**WHEELING PLAN COMMISSION
THURSDAY, JANUARY 25, 2018 6:30 P.M.**

REQUEST FOR PLAN COMMISSION ACTION
STAFF PROJECT REVIEW

RE: **Docket No. SCBA 18-3**
Boston Fish Market
412 N. Milwaukee Avenue
Appearance Approval of Wall & Freestanding Signs

RE: Docket Nos. 2017-18 and SCBA 18-4
Shri Swaminarayan Temple
397 Northgate Parkway
(2017-18) Special Use-Site Plan Amendment to Allow for a
Building Addition
(SCBA 18-4) Appearance Approval of a Freestanding Sign

IRRIGATION PLAN

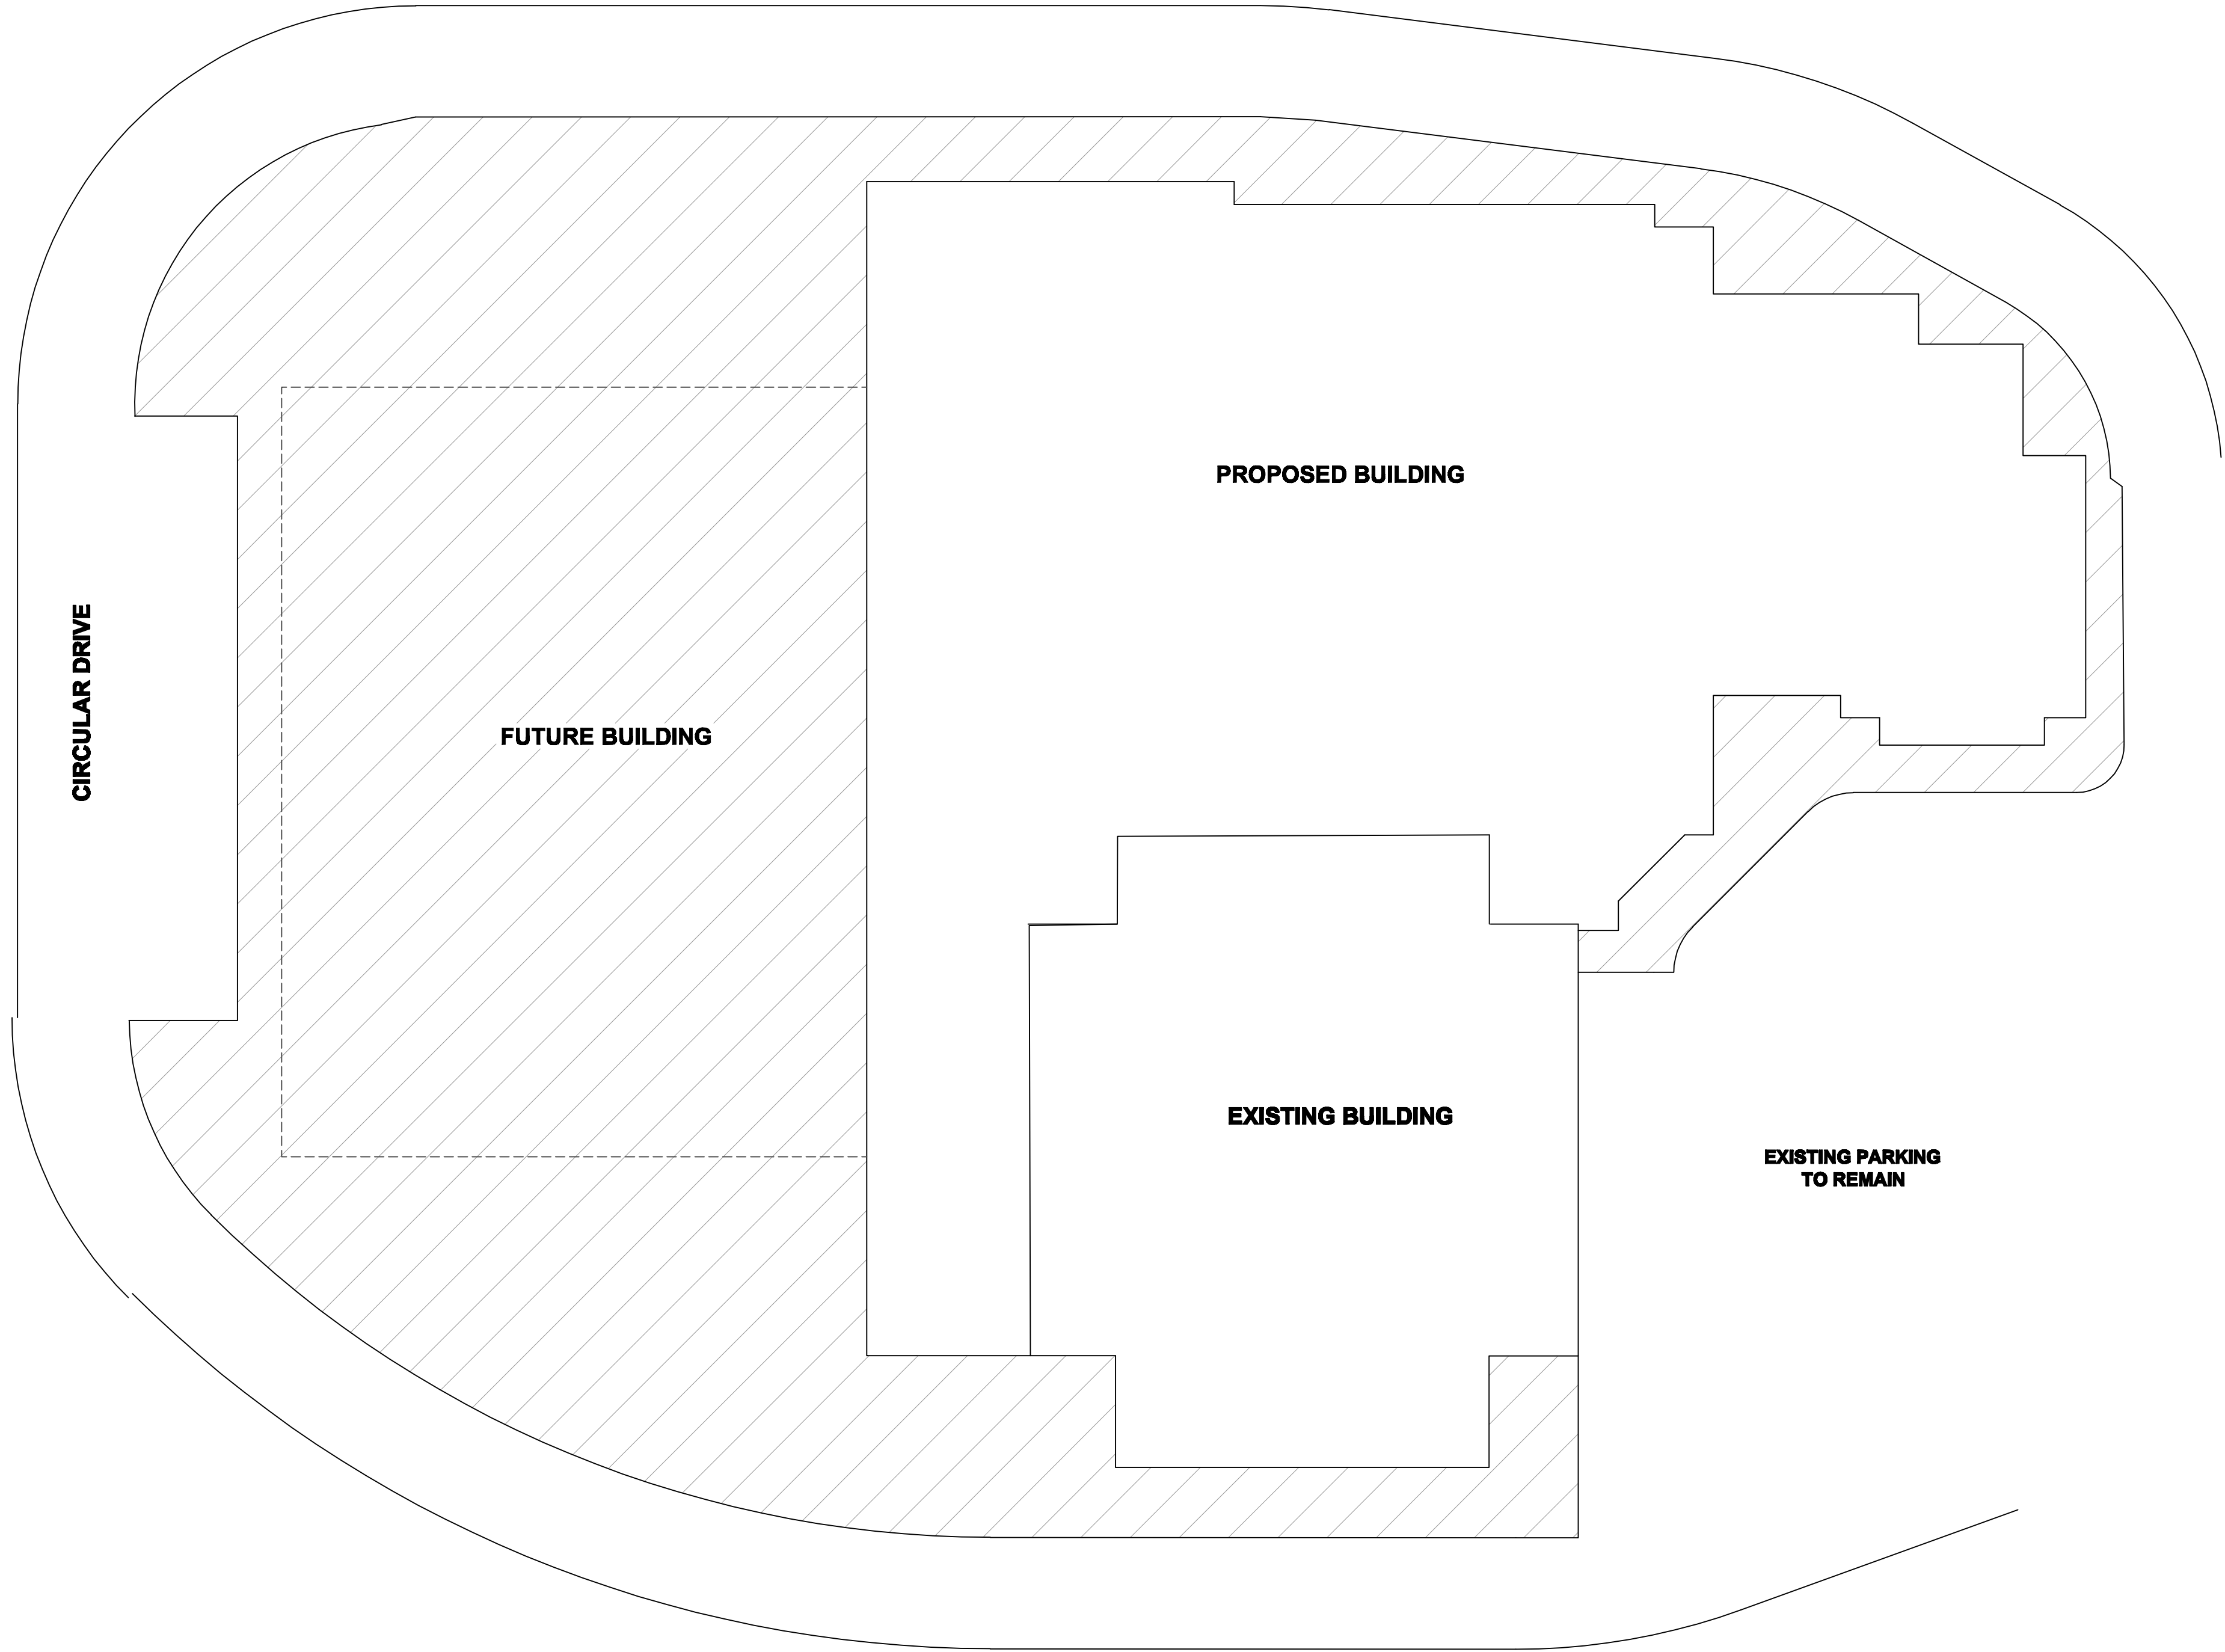
Landscape Irrigation: An irrigation plan is provided. All of the new plantings surrounding the building will be irrigated. In addition, the sodded area that will eventually be replaced by the future (Phase II) building addition will also be irrigated. The existing site is irrigated.

SOUTH ELEVATION

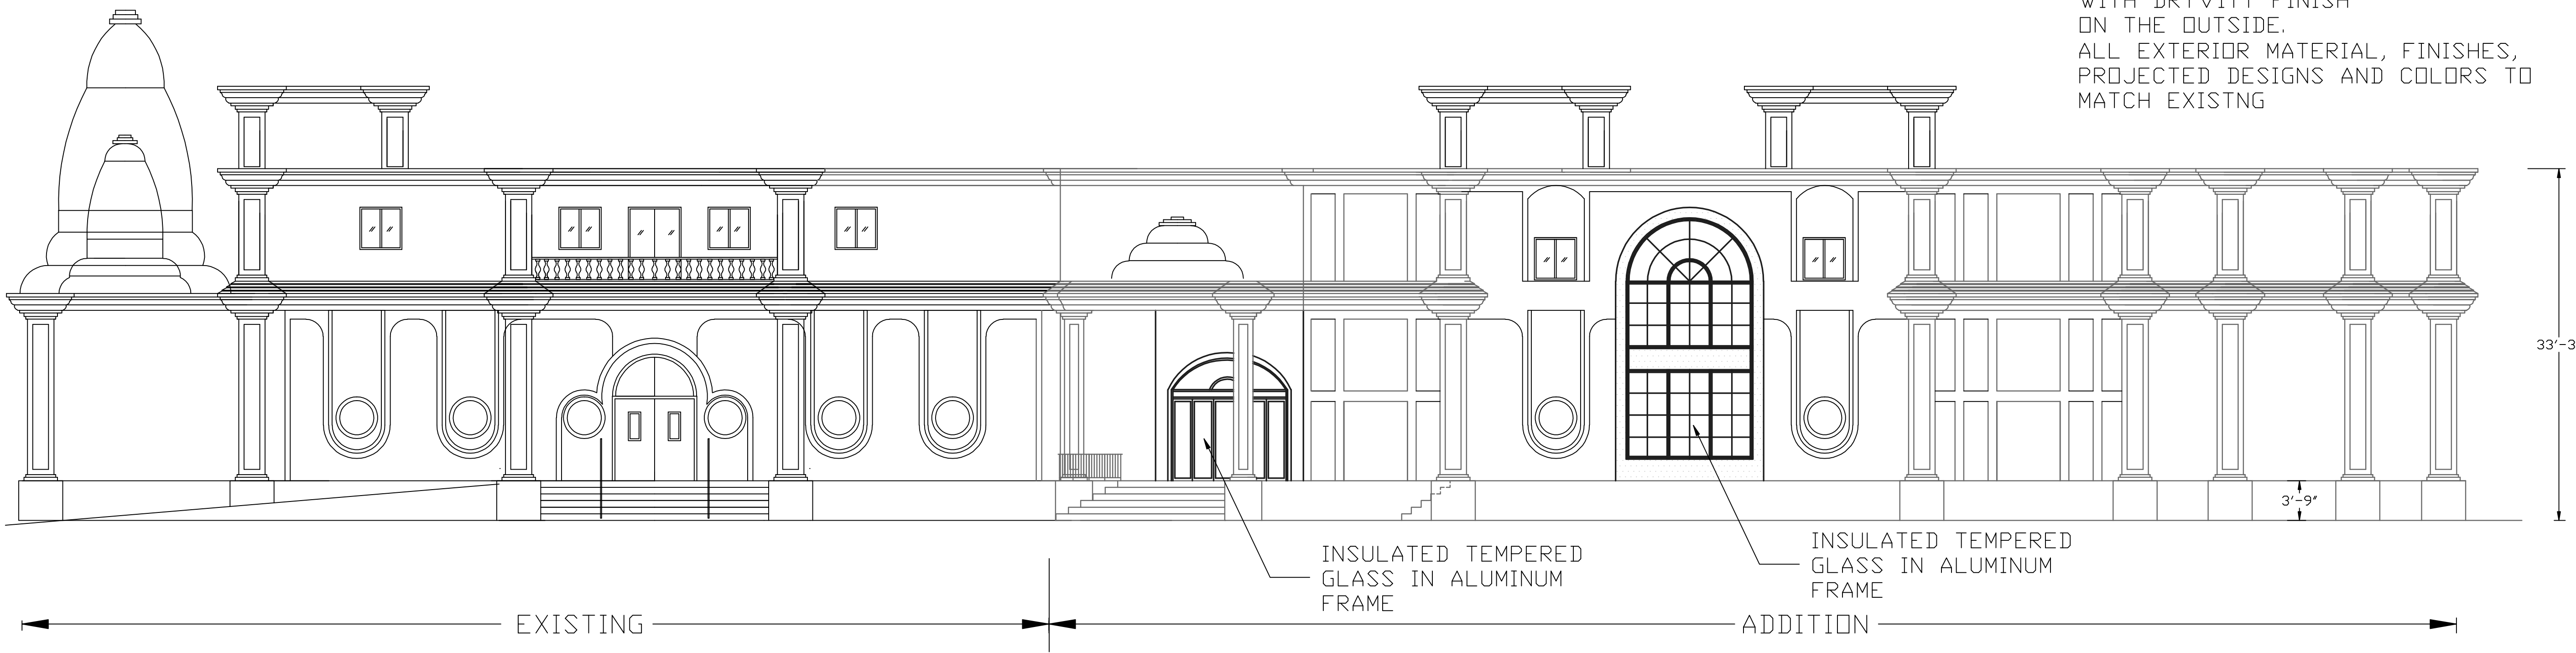
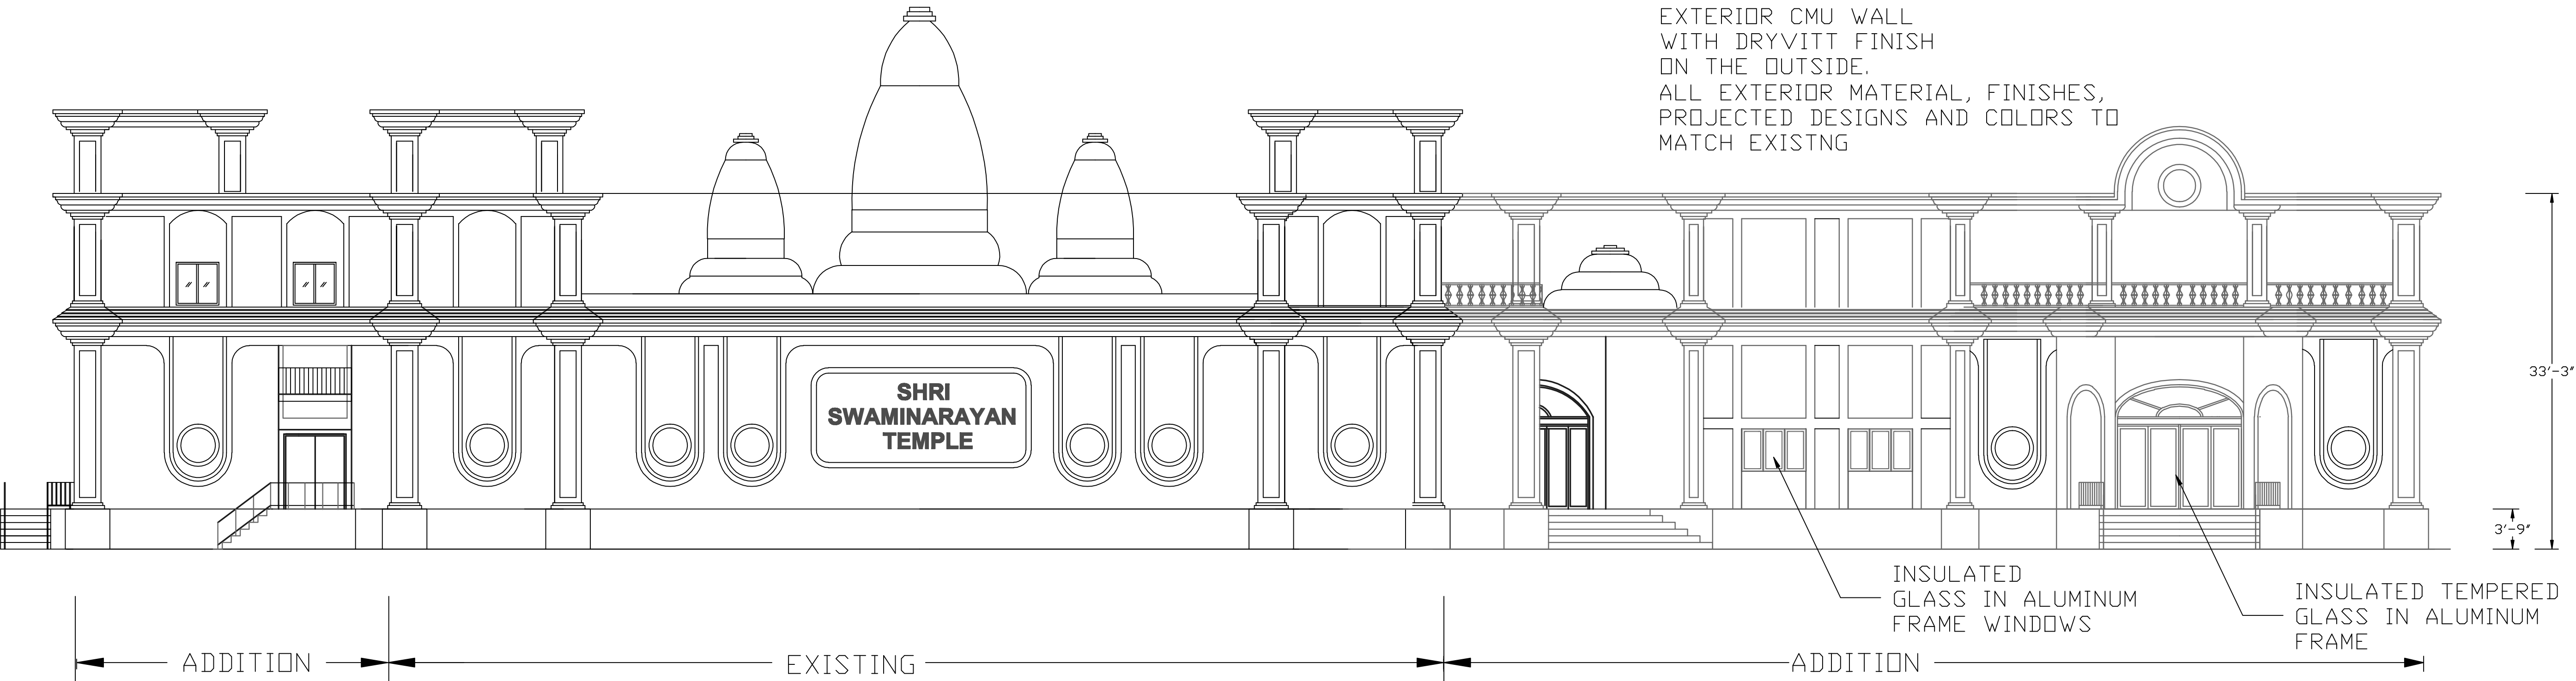
The elevation plans for the 25,075 sq. ft. addition state that it will match the design, material, finishes, and colors of the existing temple. This includes continuation of the Dryvitt (EIFS)

primary wall material. The design guidelines recommend that EIFS not be used as a primary wall material. However, the Plan Commission may allow the continued use on the addition for design continuity. If the Plan Commission has concerns regarding the durability of EIFS and its use as a primary wall material, they may ask the petitioner to consider other material options, and discuss how those materials would wear in relation to EIFS.
